Access Compliance Report

Public Rights-of-Way (Curb Ramps)

Intersection ID: 8522	Main Street: MARBLE_ST	Cross Street: WILLARD_ST	Location: W
ADA ID: EE935B7BABFC	Ramp Type: Directional1	Initial Pass/Fail: Fail	Overall Compliance: No
Severity Score: 1.25			
Codes/Mitigation Info/Possible Solution		Field Measurements/Component Compliance

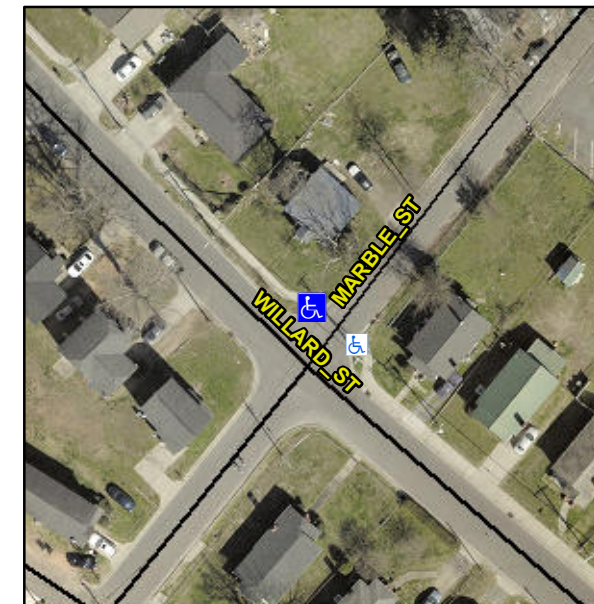
R304.5.3

Compliance	Description	Data	Compliance	Description	Data
N/A	Ramp Length (in)	87.0	N/A	Grade Break?	N/A
Yes	Ramp Width (in)	65.5	N/A	Grade Break Slope (%)	0.0
Yes	Ramp Slope (%)	5.7	N/A	Grade Break XSlope (%)	0.0
No	Ramp XSlope (%)	2.3			
N/A	Flare Type LT	N/A	N/A	Flare Type RT	N/A
N/A	Flare Slope LT (%)	N/A	N/A	Flare Slope RT (%)	0.0
N/A	Flare Traversable LT?	N/A	N/A	Flare Traversable RT?	N/A
N/A	Landing Length (in)	0.0	N/A	DWS Provided?	N/A
N/A	Landing Width (in)	0.0	N/A	DWS Contrast?	N/A
N/A	Landing Slope (%)	0.0	N/A	DWS Length (in)	N/A
N/A	Landing X Slope (%)	0.0	N/A	DWS Full Width?	N/A
N/A	Landing Curb? (Y/N)	N/A	N/A	DWS Offset LT (in)	N/A
N/A	Shared Landing?	N/A	N/A	DWS Offset RT (in)	N/A
N/A	Gutter Ponding?	0.0	N/A	Gutter Slope (%)	N/A
N/A	Gutter Lip Ht (in)	0.0	N/A	Gutter X Slope (%)	N/A
N/A	Painted X Walk1?	No		Road Slope (%)	2.4
	X Walk 1 Direction	To NE		Road X Slope (%)	1.2
	X Walk 1 Width (in)	N/A		Clear Space?	N/A

X Walk 1 Slope (%)	2.4	N/A	Clear Space to XWalk (in)	N/A
	X Walk 1 X Slope (%)	1.2	N/A	Storm Grate/Utility Hazard?	N/A
N/A	Ramp inside XWalk1?	N/A		Storm Grate/Utility Type	
N/A	Any Obstructions?	N/A			N/A
	Obstruction Type		Yes	Surface Condition? (G/P)	Good
			N/A	Curb Slope (%)	10.7

Remove & Replace Entire Ramp.
